**TOTAL SYSTEM PERFORMANCE ASSESSMENT
1995 AUDIT REVIEW**

**Nuclear Regulatory Commission
Contract NRC-02-93-005**

**Center for Nuclear Waste Regulatory Analyses
San Antonio, Texas**

May 1996

Figure 2-1. Comparison of complementary cumulative distribution functions for cumulative release

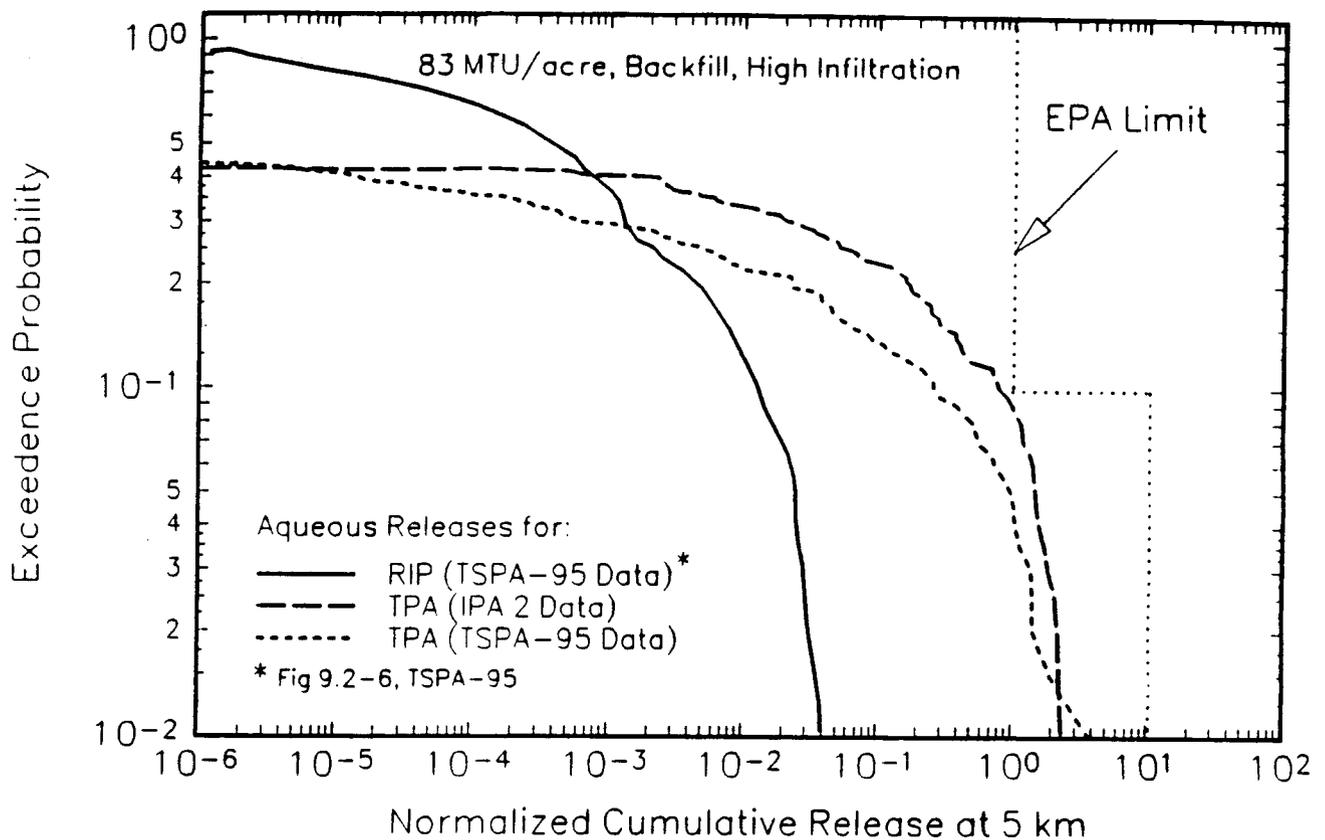
In the first case, the CCDF calculated with TPA is close to the U.S. Environmental Protection Agency (EPA) limit whereas the CCDF taken from TSPA-1995 (i.e., calculated with RIP) is about two orders of magnitude below the EPA limit. The TPA calculations produced fewer lower releases and more higher releases than indicated by the TSPA-1995 result. This suggests that the IPA Phase 2 assumptions and site subsystem abstraction may be much more conservative than those used in RIP. Also, in the TPA calculations it was assumed that once a canister failed in a given zone of the repository, all canisters within that zone also failed, which is more conservative than the assumption used in TSPA-1995.

In the second case, the CCDF computed with the TPA again has fewer low releases and more higher releases than the CCDF produced by RIP in TSPA-1995. As in the first case, the TPA calculated CCDF differs significantly from that produced by the RIP code. The comparison suggests that, even when

the data are similar, the abstracted models and conceptual representation of the system used in TPA are more conservative than those incorporated in RIP.

Figure 2-2. Comparison of particle travel-time cumulative distribution functions

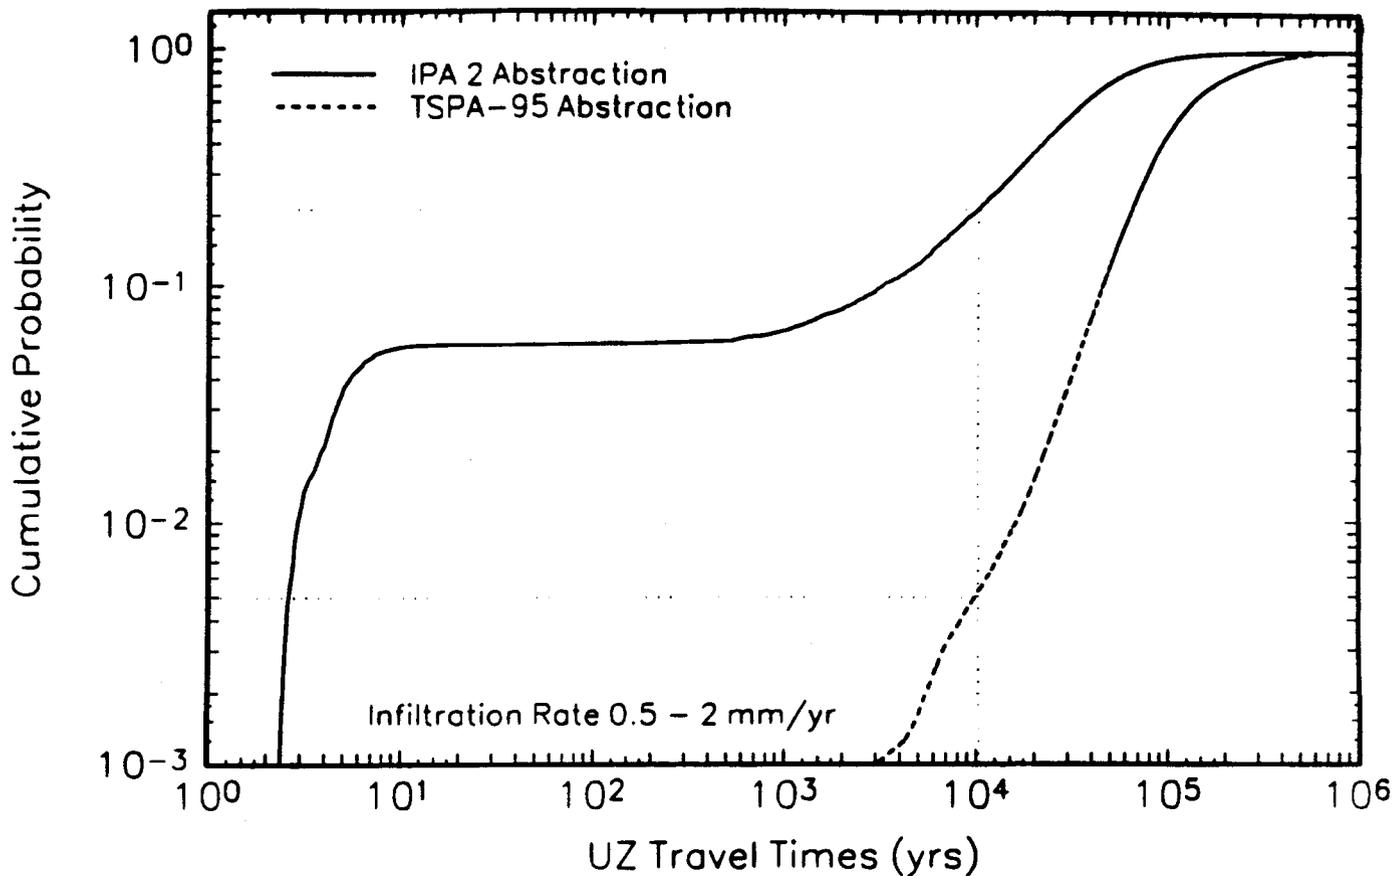
To evaluate the first of these hypotheses, the distributions of particle travel times were computed using the IPA 2 and RIP methods for particle travel time and a Monte Carlo sampling method. These calculations, performed with the MatLab software, produced CDFs for the particle travel time which are compared in Figure 2-2. As can be seen from this comparison, the CDF corresponding to the TPA model abstraction and data captures both fracture flow (i.e., fast pathways) and matrix flow behavior, whereas the RIP model abstraction and data lack an adequate representation of fracture flow.

Figure 2-3. Comparison of hydrostratigraphic models

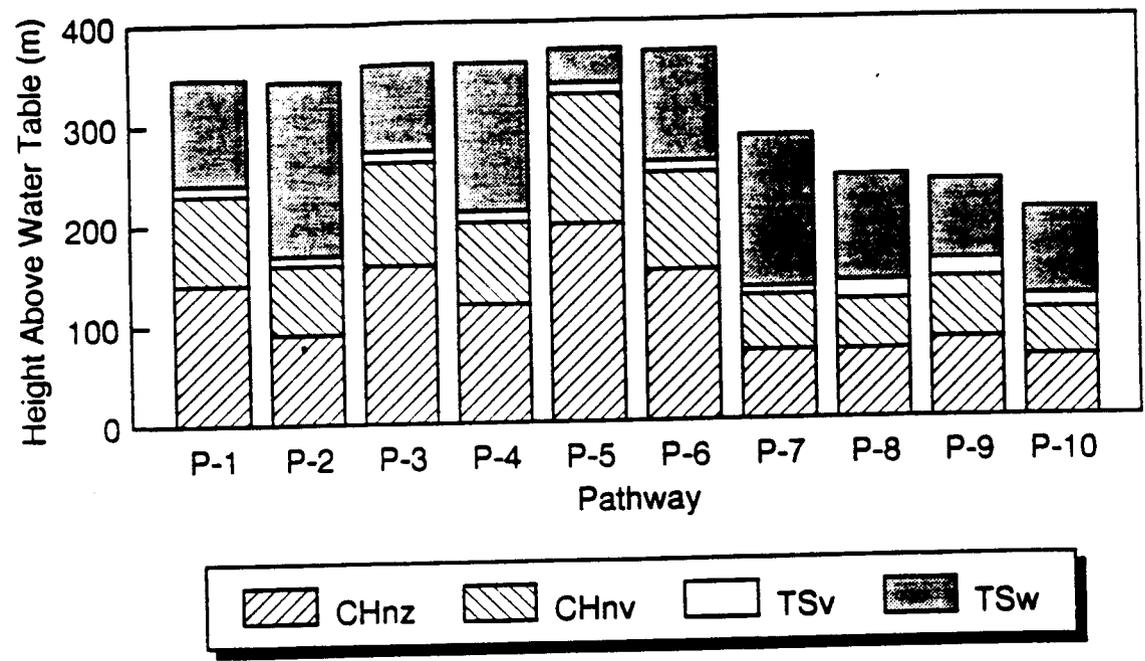
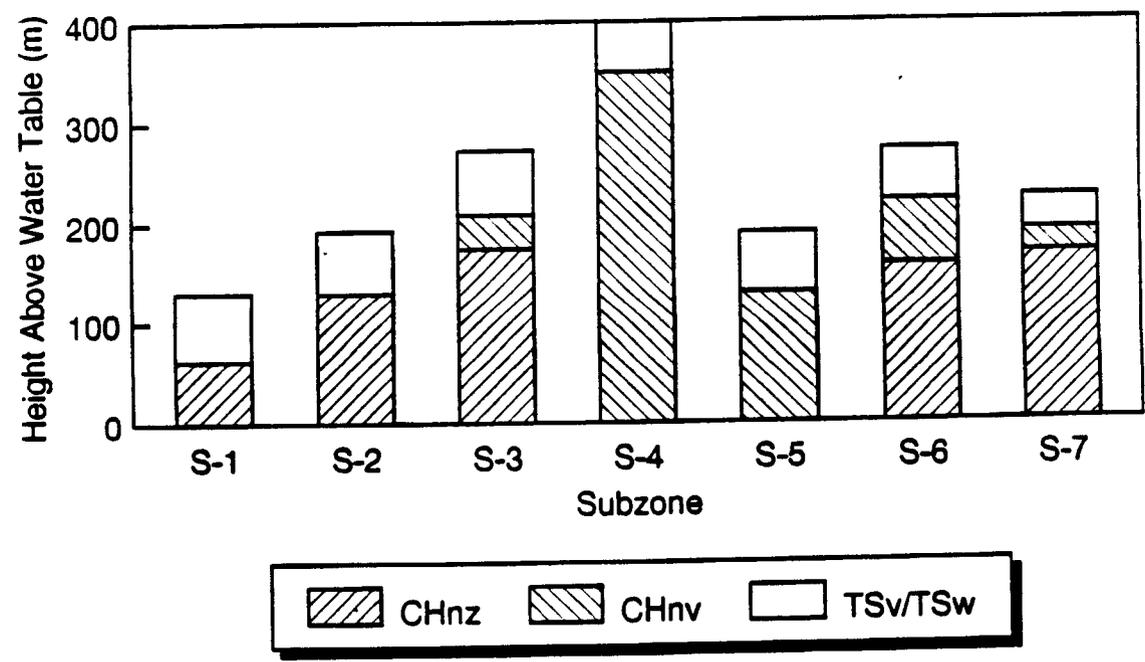
In investigating the second hypothesis, the hydrostratigraphic models used in IPA 2 and TSPA-1995 were graphically compared (Figure 2-3). As can be seen from this comparison, the first six pathways (i.e., hydrostratigraphic columns that apply to the high heat load case) of the TSPA-1995 model are, in general, much longer than the IPA 2 subzone columns. In addition, the TSPA-1995 differs in that: (i) the Topopah Springs unit is subdivided into vitric (TSv) and welded (TSw) components and (ii) the Calico Hills nonwelded zeolitic (and low permeability) subunit is present in all of the TSPA-1995 pathways, in contrast to the IPA 2 model where it is absent in two of the seven columns. The longer path length and lower effective conductance of the flow path explains to a large degree the very long particle travel times computed in TSPA-1995. The absence of the short particle travel times or fast pathways in the TSPA-1995 are believed to be due to three aspects of the RIP particle travel time method: (i) matrix diffusion effect introduced by the Markovian method, (ii) formulation error in the calculation of the pore water velocity (i.e., Darcian flux should be divided by moisture content rather than effective porosity), and (iii) inadequate number of realizations in the process-level simulations used to estimate the effective ranges of matrix velocities and fraction of fracture flow.

Figure 4-1. Comparison of process-level simulations with abstractions for an infiltration flux of 2 mm/yr

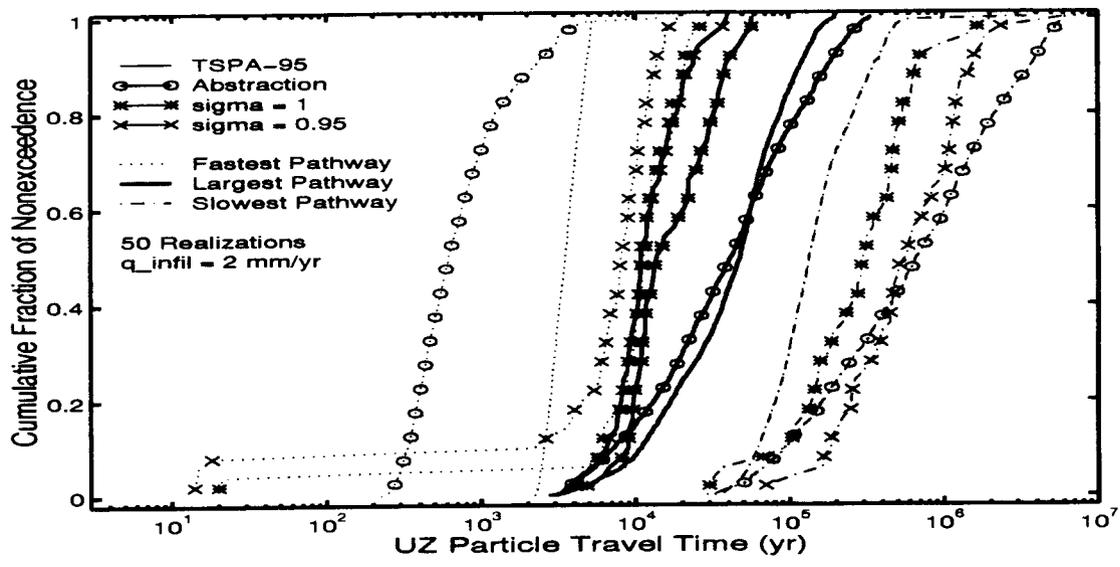
Examining the behavior of the 2 mm/yr case in Figure 4-1, it can be seen that the statistical behavior of the particle travel times for the process-level pathways is somewhat different from the behavior of the corresponding abstraction pathways. In particular, the process-level simulations exhibit a relatively low but non-negligible probability of extremely fast pathways, on the order of decades, while the largest-flux pathways and most of the fastest pathways are on the order of 10^4 yr. Incorporating a total of 320 simulations (not shown here due to space limitations) suggests that there is a small probability that the largest-flux pathways may also be on the order of decades. On the other hand, the abstraction from these process-level simulations has fastest pathways at least 200 yr, usually on the order of 1,000 yr;

largest-flux pathways generally tend to be several times slower than the corresponding process-level simulations. By comparing the 50-realization abstraction with the TSPA-1995 abstraction, it can also be seen that considering 50 material-property realizations, rather than ten realizations, has the effect of making the fastest pathways faster and the slowest pathways slower.

Figure 4-2. Comparison of process-level simulations with abstractions for an infiltration flux of 0.01 mm/yr

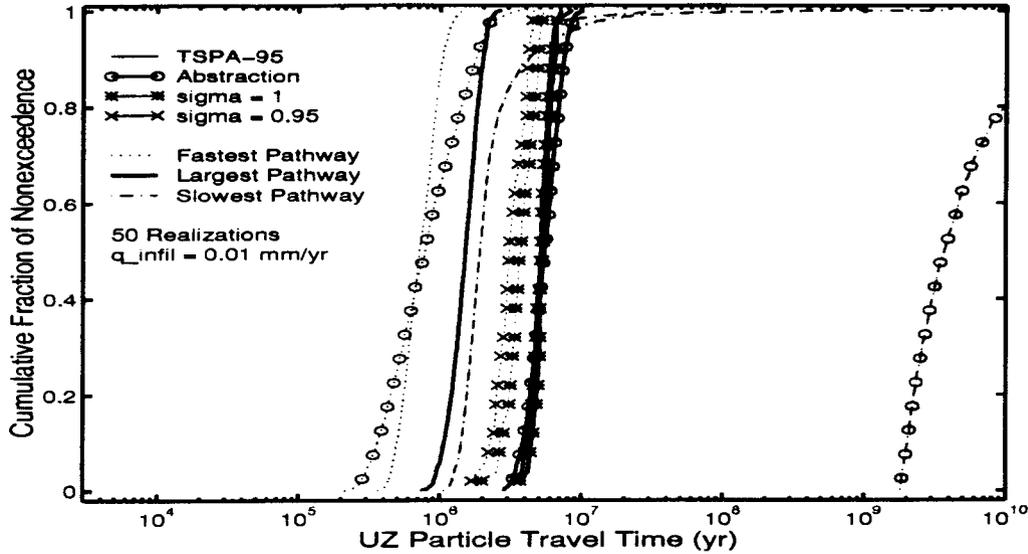
Examining the behavior of the 0.01 mm/yr case in Figure 4-2, the abstraction can be seen to have a drastic impact on the spread of particle travel times, but does not strongly affect the largest-flux pathways. It is not clear whether an artificial spread in travel times means the abstraction is conservative. Admittedly, the very low velocities would yield no releases in 10⁴ yr.

Figure 5-2. Results from two-dimensional model

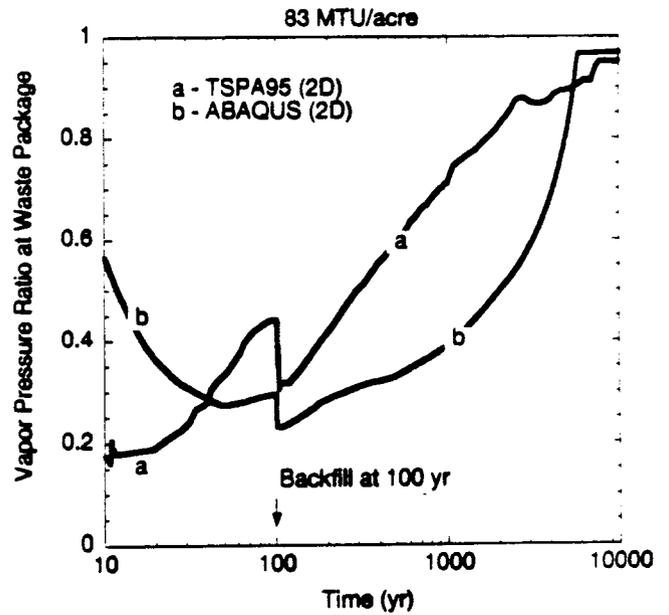
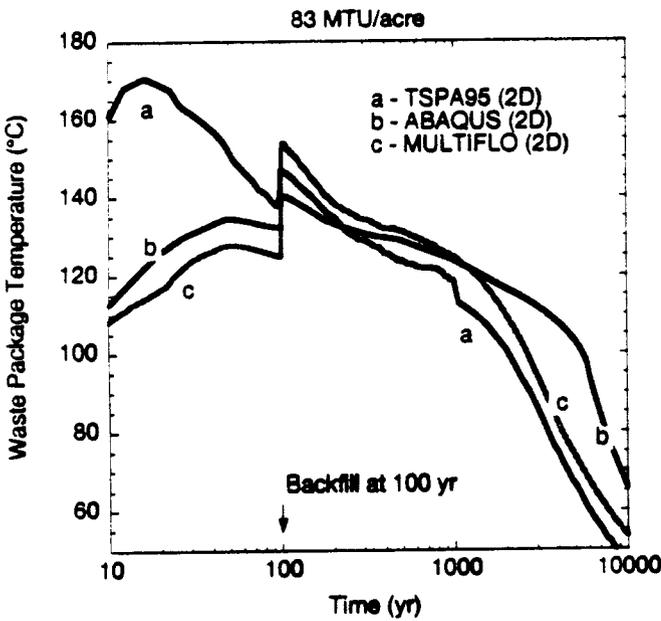
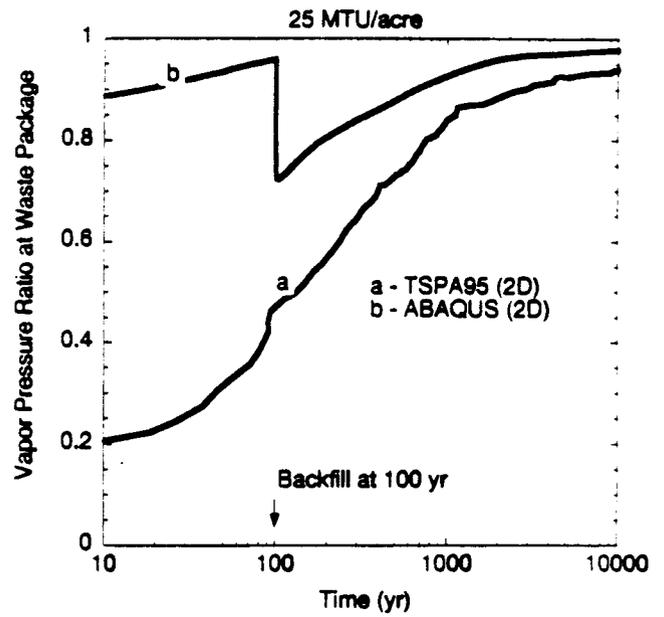
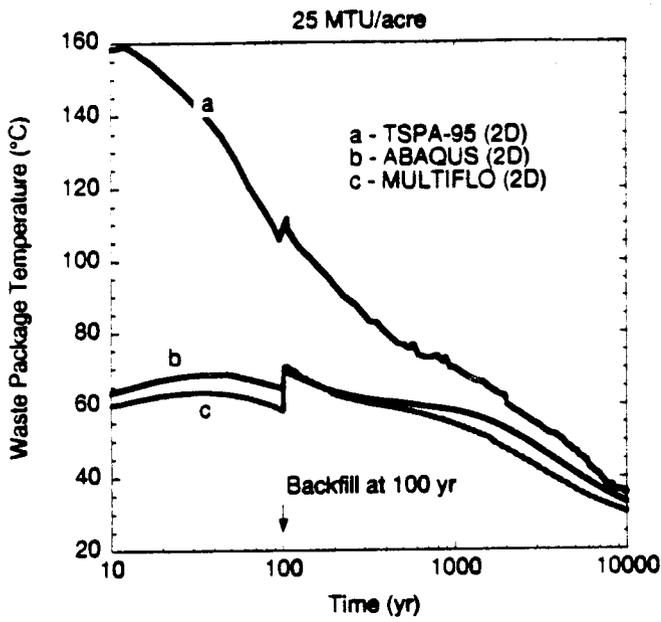
In Figure 5-2, TSPA-1995 results and CNWRA independent calculations are compared for the 25 and 83 MTU/acre cases. For the 2D, 25 MTU/acre results, the temperatures and vapor pressure ratio are in general agreement at long times. For the first few hundred years, the TSPA-1995 results show a higher WP temperature and resulting lower vapor pressure ratio. In general, the TSPA-1995 results show higher WP temperatures prior to backfilling. After reviewing the description in TSPA-1995, it is believed that this trend is due to underestimating the rate of radiative heat transfer from the WP to the drift wall prior to 100 yr. However, this could not be confirmed due to sparse documentation of the details in TSPA-1995. The report states that a radiative transfer model was employed but does not discuss how view factors were calculated nor does it discuss emissivity values for the package or drift wall.

For the 2D, 83 MTU/acre case, the temperature and vapor pressure ratio results are in better agreement. Again, the TSPA-1995 results show higher temperatures prior to backfill but essentially the same as the MULTIFLO code out to 10,000 yr. A curious anomaly in the TSPA-1995 results is that there is essentially no change in vapor pressure ratio due to backfilling the drift at 100 yr. As the WP temperature increases at backfilling, the vapor pressure ratio is expected to decrease but this trend is not evident in the TSPA-1995 simulation results.

Figure 5-3. Three-dimensional model

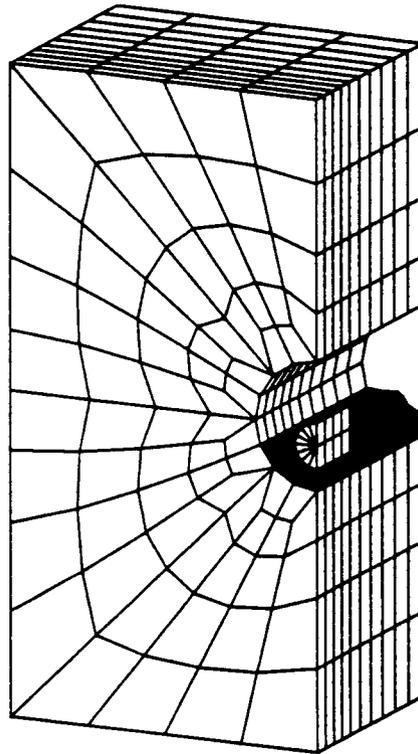
A 3D model is shown in Figure 5-3 and is used to predict WP temperature. The 3D model is motivated because the 2D model averages the heat source along the drift and this typically results in underpredictions of the WP temperature. The magnitude of the underprediction is uncertain, hence these calculations have been pursued. In Figure 5-4, the WP temperatures are compared for the 2D and 3D models using only the ABAQUS code. The 3D model more accurately captures the geometry and thermal evolution of the problem. After backfill, the near-field heat transfer around a WP is truly 3D. The results show that the 3D model predicts higher temperatures throughout the time of interest. Promptly after backfilling, the temperature difference is most distinct. For both the 25 and 83 MTU/acre cases, the WP temperature is about 80 °C higher for the 3D case promptly after backfill.
